“Grand Terrace” Annexation

CITY OF
ASHLAND

Planning Commission
Cont'd Public Hearing
July 28, 2020

Driveway Treatment

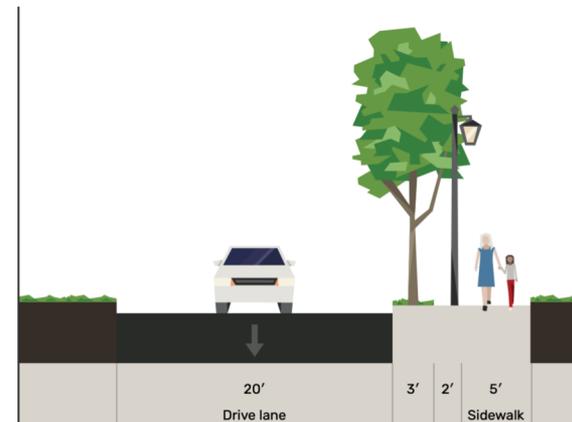
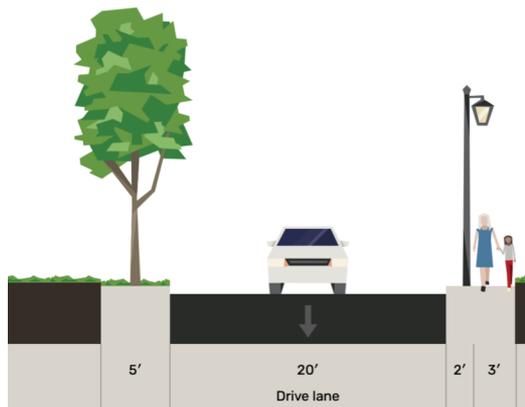
Staff Comments: With Site Design Review, the applicant will need to show at least two driveway access points to the development, and will need to address Vehicle Area Design standards *on-site*, and the Planning Commission will ultimately need to determine whether an ingress/egress easement over another property not under the applicant's ownership (and not in the city) constitutes "on-site" circulation to require "street-like features." A 30-foot width with a 20-foot paved surface would have ten additional feet to accommodate a five-foot sidewalk, curb, street trees/landscaping and lighting.

Staff Comments: With more than seven spaces served and a length greater than 50 feet, the driveway would need to be 20-feet in width and meet the grade requirements for a flag drive.

Staff Comments: Staff would also point out that AMC 18.4.3.090.B.4.a provides that the approval authority may approve a walkway abutting a driveway at the same grade as the driveway if the walkway is distinguished from vehicle-maneuvering areas. Examples of alternative treatments are mountable curbs, surface treatments such as stamped concrete or reflector bumps, and using a row of decorative metal or concrete bollards to separate a walkway from a driveway.

Staff Comments: A five-foot landscaping buffer containing trees could be provided adjacent to the driveway where abutting a property line and still have room for a five-foot sidewalk. Staff believes that the available width can provide needed access to the site with final design details to be worked out by the applicant and neighbors prior to bringing a Site Design Review application forward.
